BURLINGTON DEVELOPMENT REVIEW BOARD

Tuesday August 21st, 2018, 5:00 PM

PUBLIC HEARING NOTICE

TO: Development Review Board
FROM: Scott Gustin
DATE: August 21, 2018
RE: 18-1190CU; 233 Pearl Street

MILLER BUILDING SIGN DETAIL
 SCALE: 3/8" = 1 FOOT

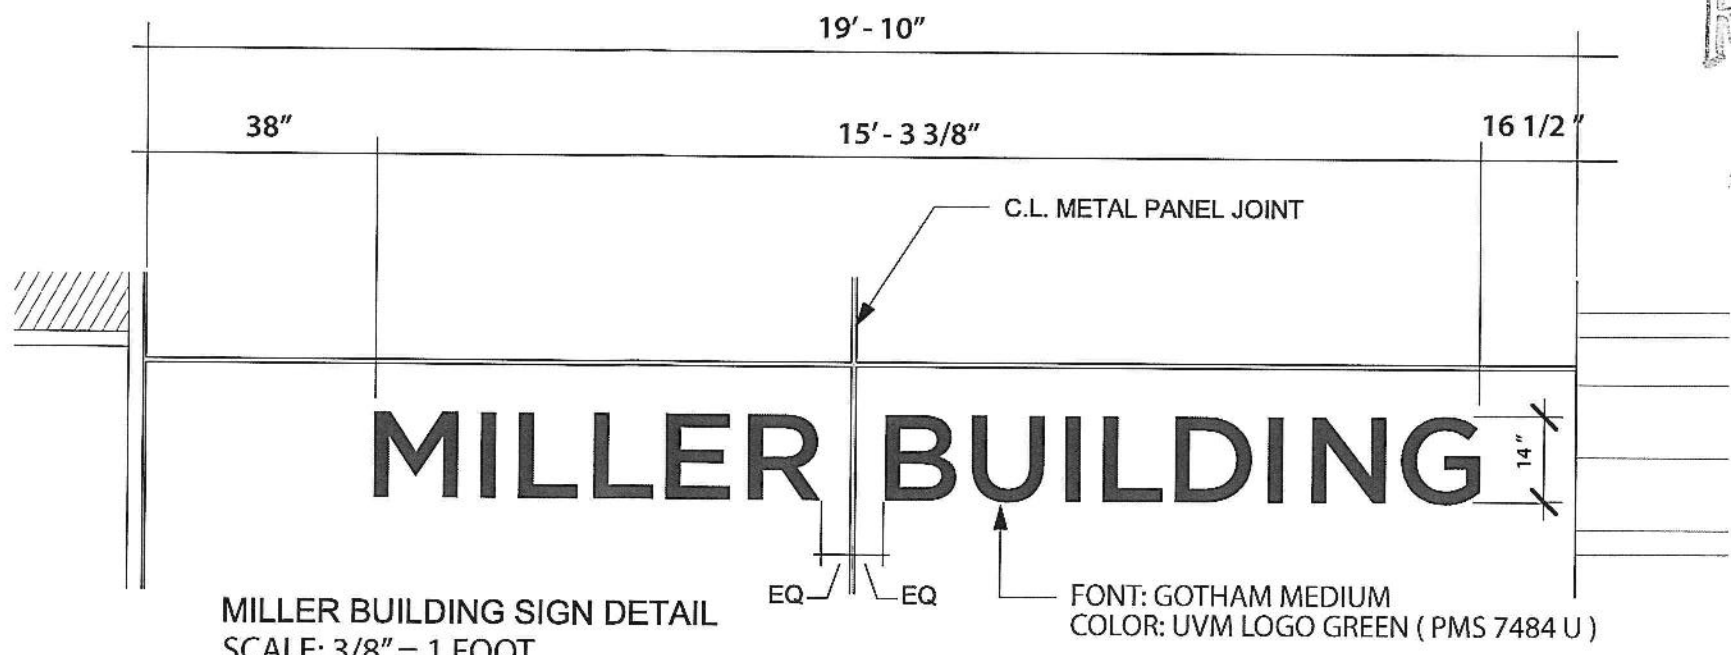
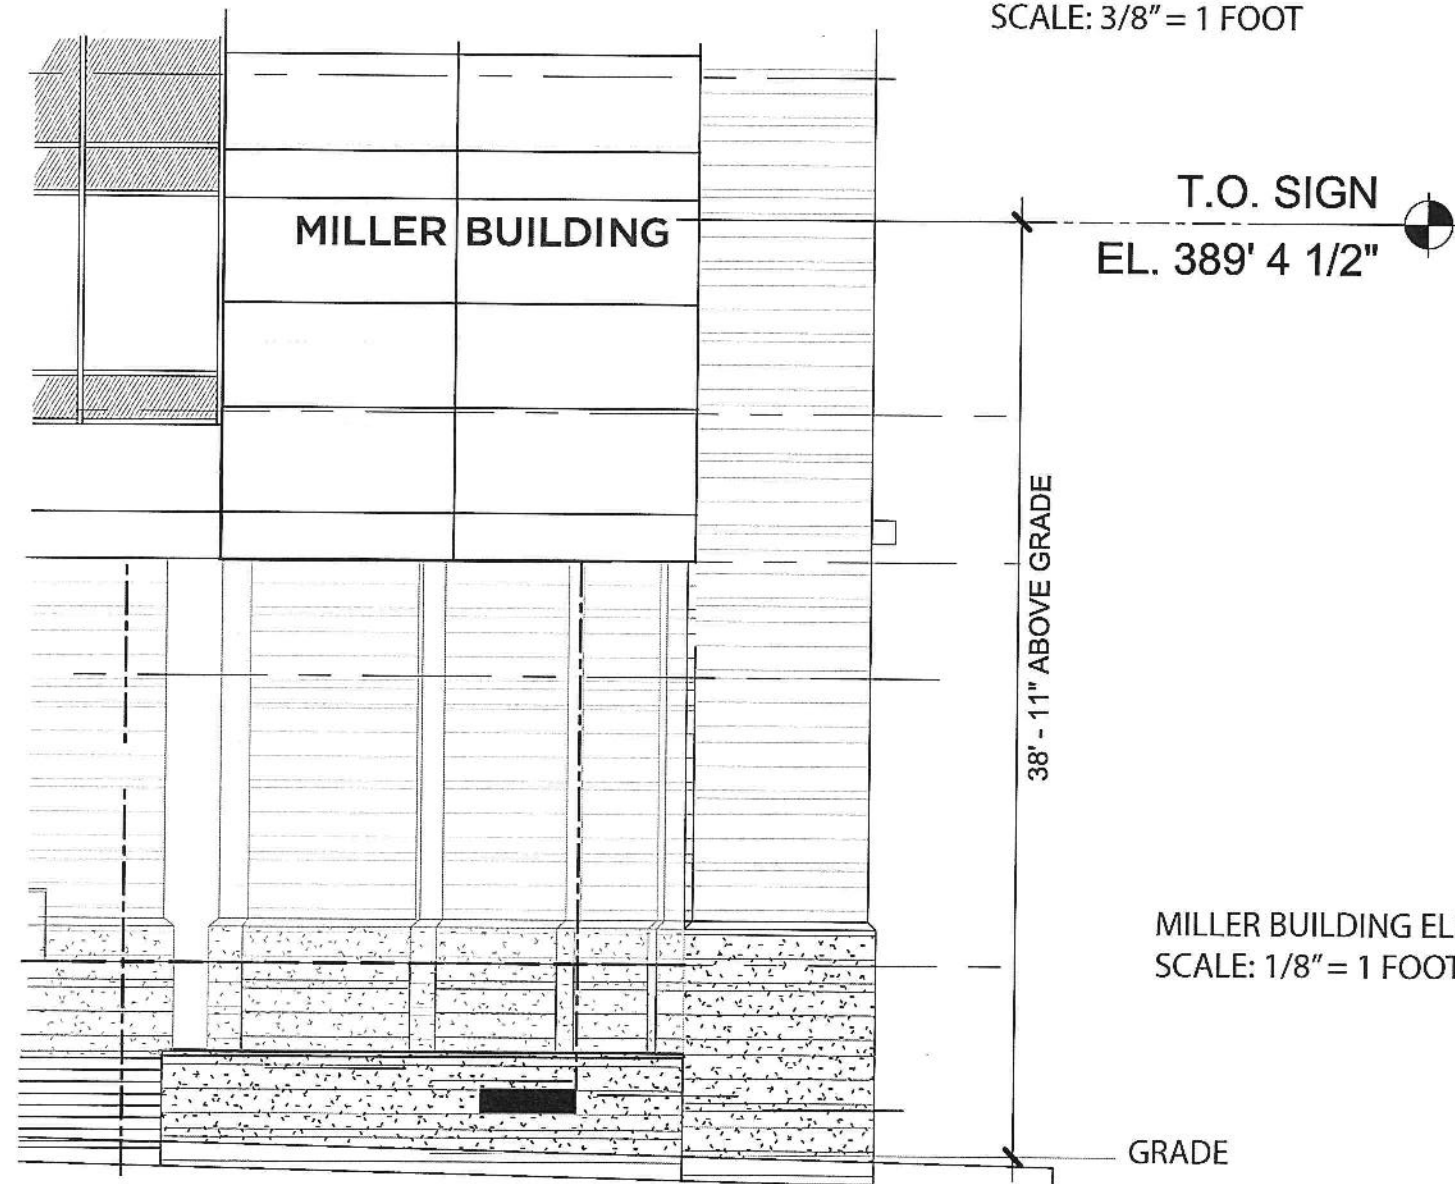
The new “Miller Building” parallel sign consists of individual letters affixed to the building exterior. It is stylistically similar to the “Fletcher Allen” (now UVM Medical Center) sign mounted on the hospital’s east pavilion, also approved above the standard 14’ height limit by way of previous sign plan amendment. **(Affirmative finding)**
